Subject: **7943-M3 Mulcahy Field Improvements- Phase II/DPWP-ARPA**

ADDENDUM NO. 6

MULCAHY FIELD IMPROVEMENTS, PH II

MULCAHY FIELD IMPROVEMENTS, PHASE II

SHEET E-1

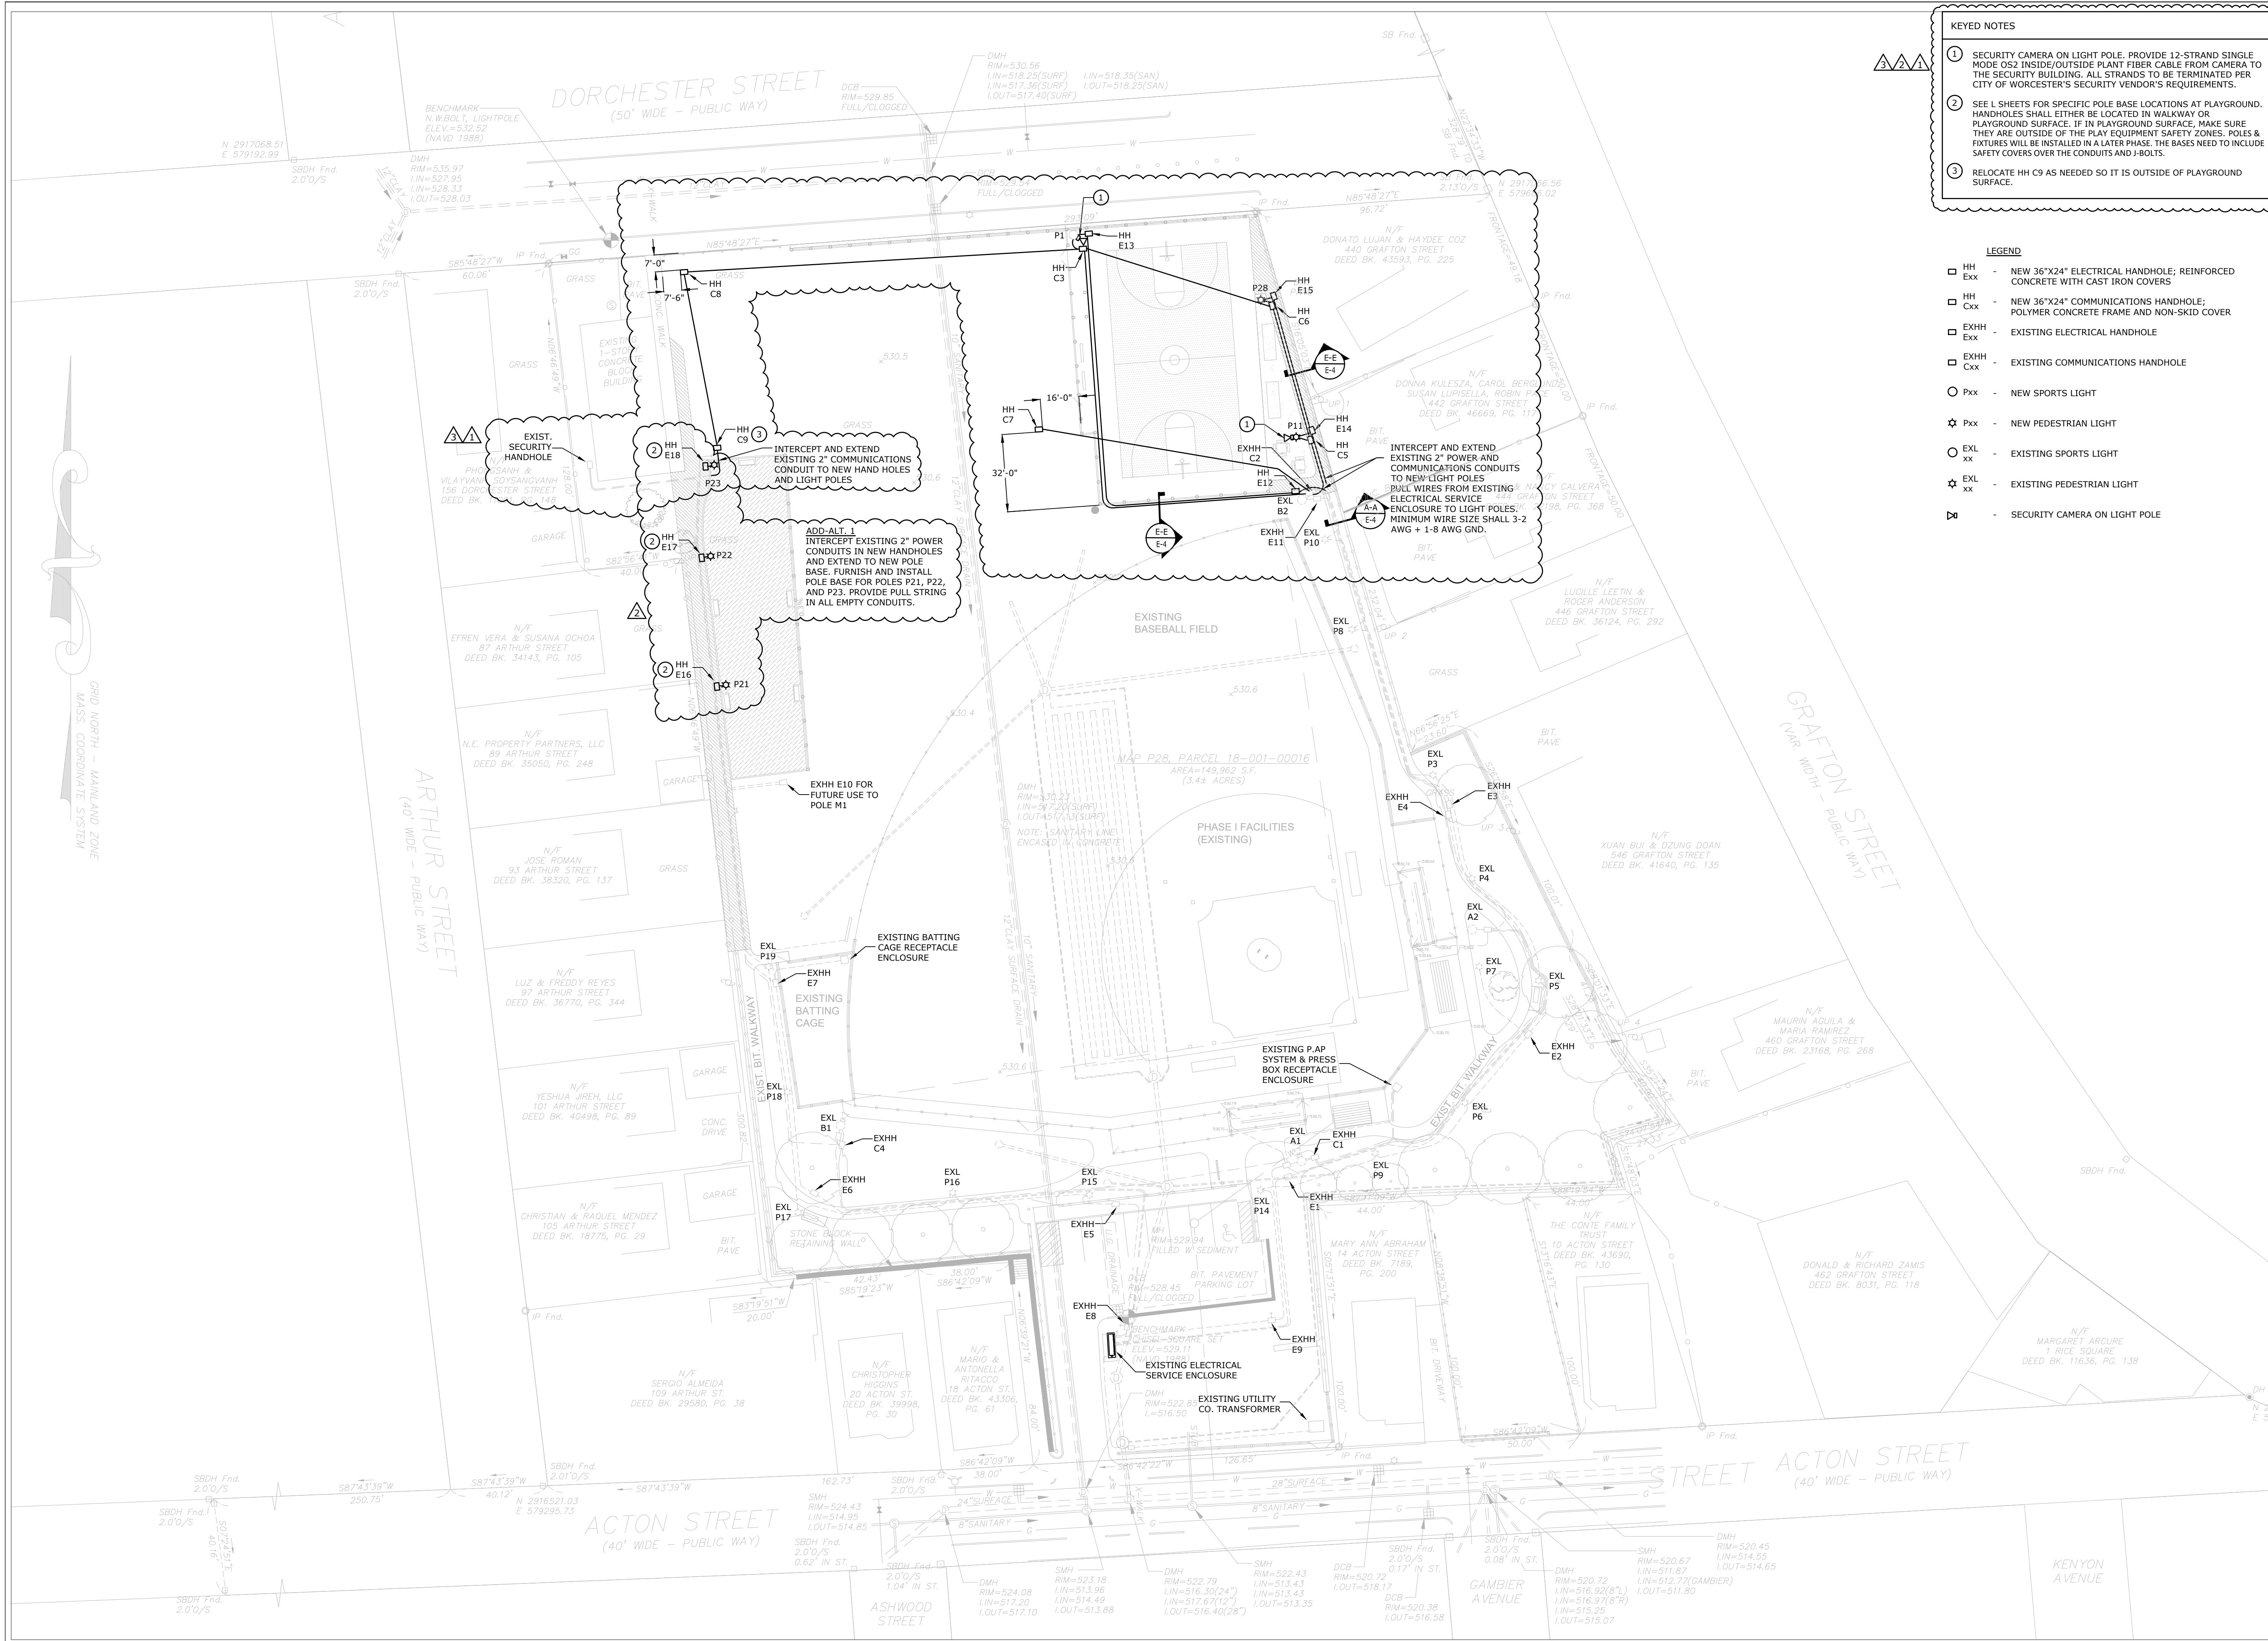
Question 1: The addendum 5 response to question 2 is still not clear. We do not find the routing of the fiber optic cable on drawing E-1. Does the cable dead end in the “existing security handhole” shown in the upper left of the drawing? If so please substantiate the need for 1,000’ of cable. We only find the need for approximately half that amount.

Question 2: Please confirm that the 1,000 feet of fiber optic cable called for in Special Conditions Article 40 includes furnishing, installing and testing the 12 strand, and does not include splices, splice enclosures, terminations, whips, patch panels, or any additional hardware.

Answer 1: Fiber optic cable dead ends in the building. Conduit runs from Building to the existing “security hand hole” shown in the upper left of the drawing. See attached Revised Article No. 41 referenced above.

Answer 2: Revised Article No. 41 includes splices, splice enclosures, terminations, whips, patch panels, and any additional hardware. See attached Revised Article No. 41 referenced above.

- 1 SECURITY CAMERA ON LIGHT POLE. PROVIDE 12-STRAND SINGLE MODE OS2 INSIDE/OUTSIDE PLANT FIBER CABLE FROM CAMERA TO THE SECURITY BUILDING. ALL STRANDS TO BE TERMINATED PER CITY OF WORCESTER'S SECURITY VENDOR'S REQUIREMENTS.
- 2 SEE I-SHEETS FOR SPECIFIC POLE BASE LOCATIONS AT PLAYGROUND. HANDHOLES SHALL EITHER BE LOCATED IN WALKWAY OR PLAYGROUND SURFACE. IF IN PLAYGROUND SURFACE, MAKE SURE THEY ARE OUTSIDE OF THE PLAY EQUIPMENT SAFETY ZONES. POLES & FITURES WILL BE INSTALLED IN A LATER PHASE. THE BASES NEED TO INCLUDE SAFETY COVERS OVER THE CONDUITS AND J-BOLTS.
- 3 RELOCATE HH C9 AS NEEDED SO IT IS OUTSIDE OF PLAYGROUND SURFACE.
